Site Development Plan Comments V2.pdf Markup Summary

[1] S-1 Site Development Plan (2)

[2] S-2 Parking Plan (5)

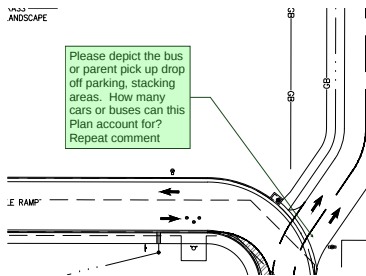
provide the actual setback numbers and 15' buffer at north and west property line required and line.

provide the actual setback numbers and 15' buffer at north and west property line required and line.

The building setbacks along the north and west have been set to 15'. added screen fence on the north side, and callout on the west side

Dimensions have been added to the site development plan for the buffer/setback distance on each property line.

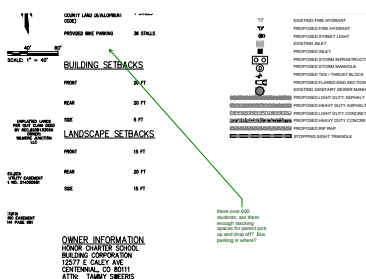
Please depict the bus or parent pick up drop off parking, stacking areas. How many cars or buses can this Plan account for? Repeat comment

Please depict the bus or parent pick up drop off parking, stacking areas. How many cars or buses can this Plan account for? Repeat comment

there over 600 students; are there enough stacking spaces for parent pick up and drop off? Bus parking is where?

(E)Truck Loading and Turnaround Areas.
(1)Truck Loading and Turnaround Areas Required. Loading and turnaround areas shall be provided for all non-residential buildings of 3,000 square feet or greater. Maneuvering or access areas may be located on adjacent lots or parcels as long as a recorded document is provided for common use and maintenance. See Table 6-6 in Code

where do the food delivery trucks load and unload? Repeat comment

buffer required at northern and western property lines. PUD Condition of approval

added line in summary table for vehicle stacking, and are shown on S-2 Parking plan. A note has been added to state there are no buses for this site.

added line in summary table for vehicle stacking. There is no bus parking.

added and adjusted truck loading and turnaround area striping, and call outs

TAIT Response:
added and adjusted truck loading and turnaround area striping, and call outs. See screenshot below for the area of loading stalls.

TAIT Response:
A solid 6' tall wood picket fence will be provided at the northern and western property lines where not already screened by adjacent private fences.
